Service Bulletin

Subject: REAR DOOR WEATHERSTRIP OUT OF POSITION	Bulletin No: 09-029/13
	Last Issued: 11/05/2013

2014 Mazda6

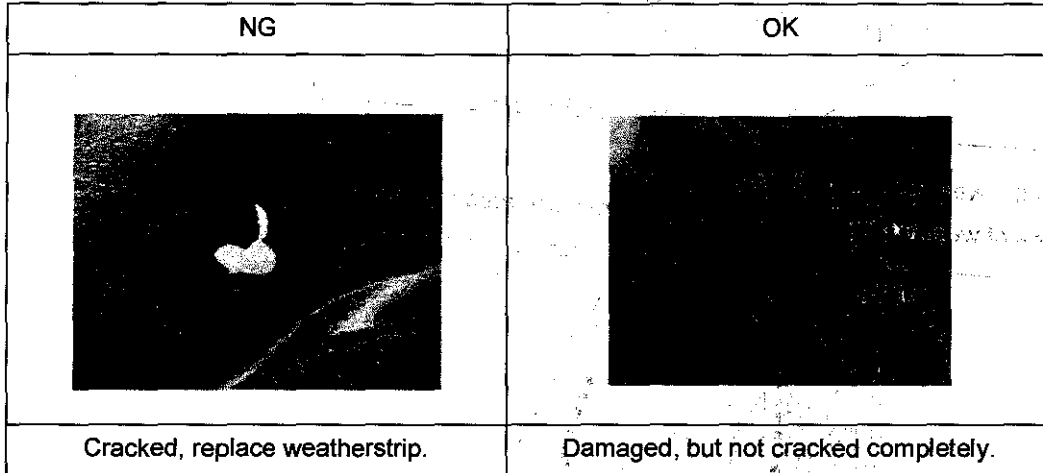
Some customers may have a concern with the top edge of the rear door weatherstrip (A) detached from fastener (B).

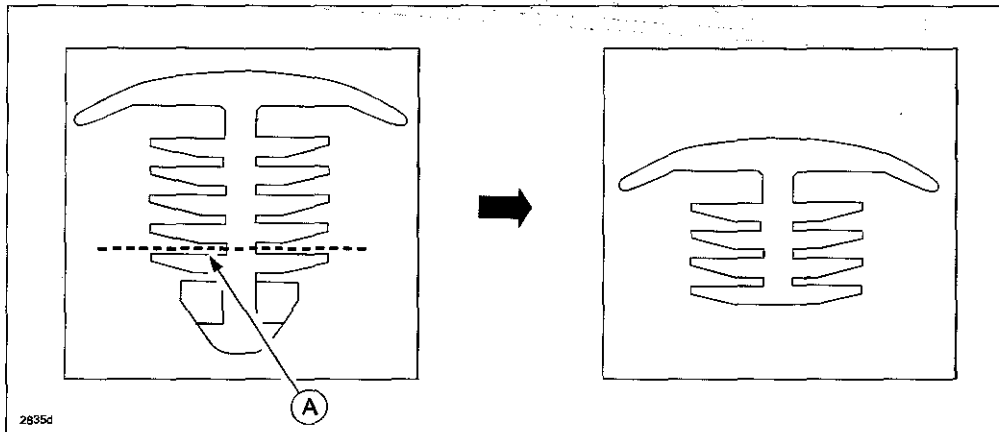
1. Verify if the weatherstrip fastener hole is not cracked as shown below. If cracked as shown "NG", replace weatherstrip. If damaged, but not cracked completely as shown "OK", reuse old weatherstrip.

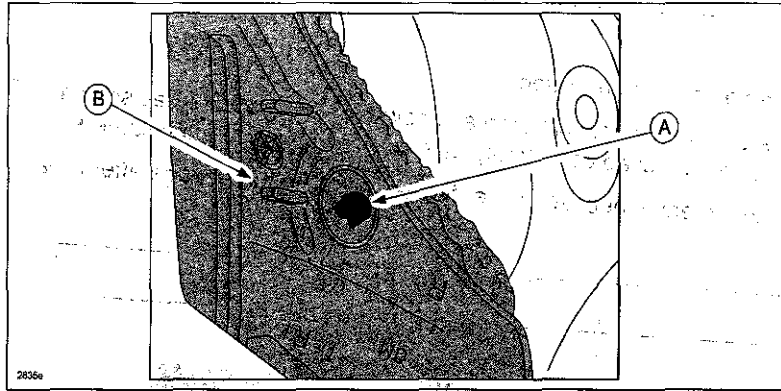
3. Cut off one notch from the end (A) of the new fastener (GHY0-58-762) as shown.

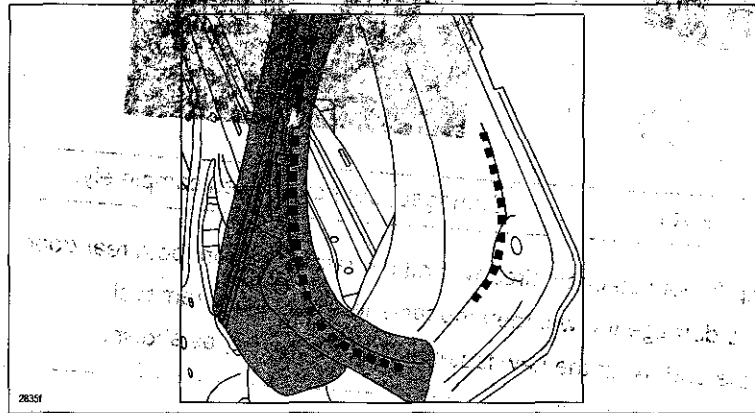
4. Install the cut fasteners (A) to both rear doors' weatherstrip (B).

NOTE: Do not install the weatherstrip to the door panel yet.

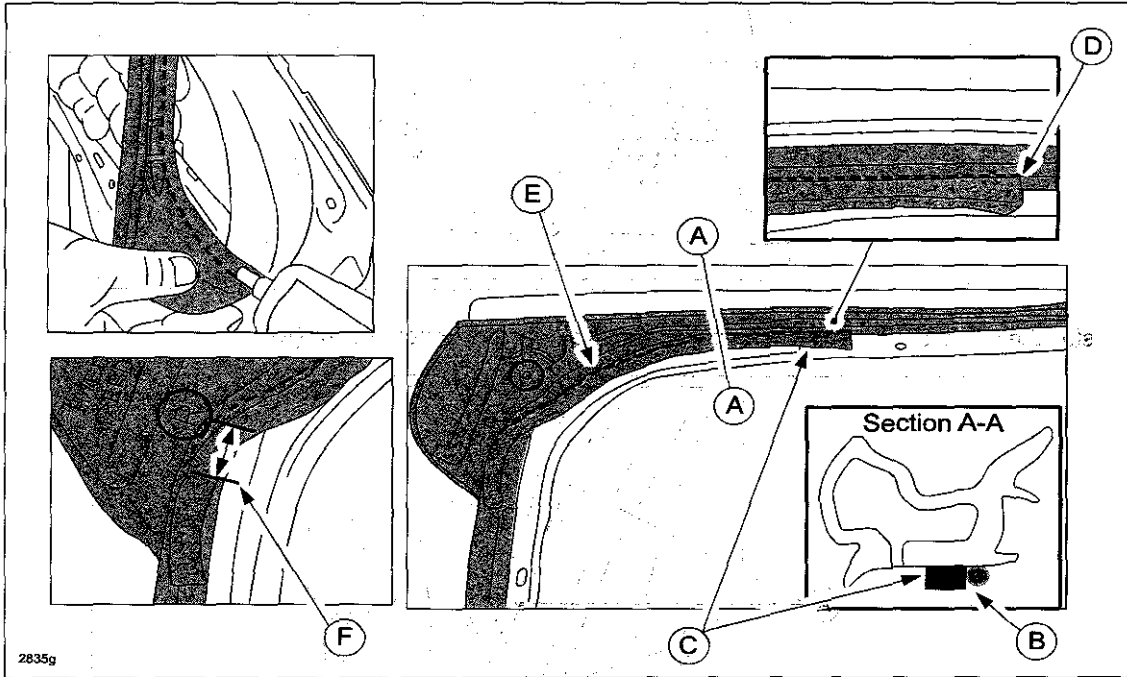
5. Clean the bonding area of weatherstrip and door panel. (Dotted line area of image).

6. Apply a 4 mm round bead (B) to the outside of the ethylene-propylene terpolymer (EPT) sealer (C) starting from point (D). Continue bonding as shown in the dotted line (E) up to 10 mm below R or L mark (F).

NOTE: Minimize bond waste by not applying more than 10 mm below R or L mark (F).

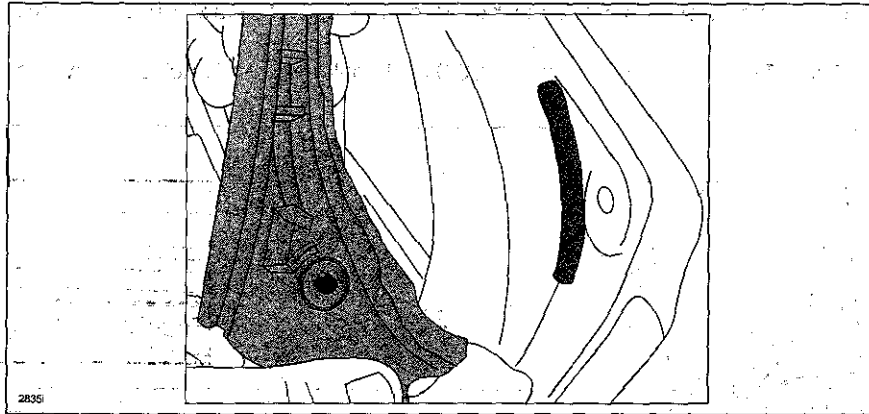
7. Apply a 4 mm round bead to the door panel as shown:

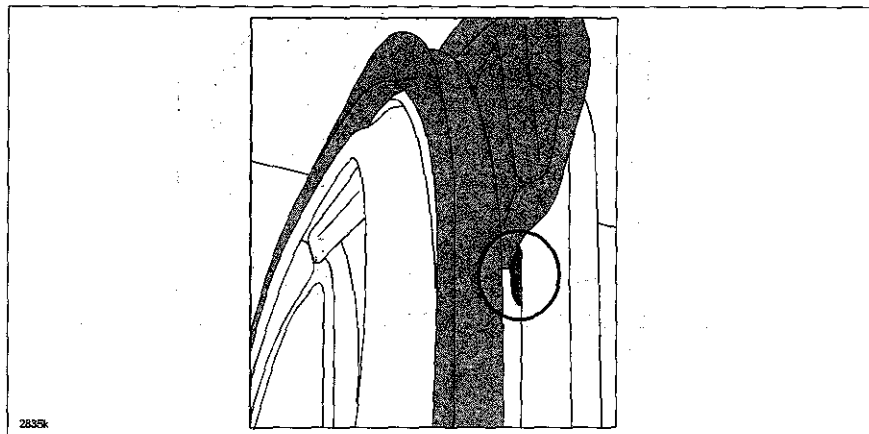
9. Install the weatherstrip to the door panel and press on the bonding area (A).
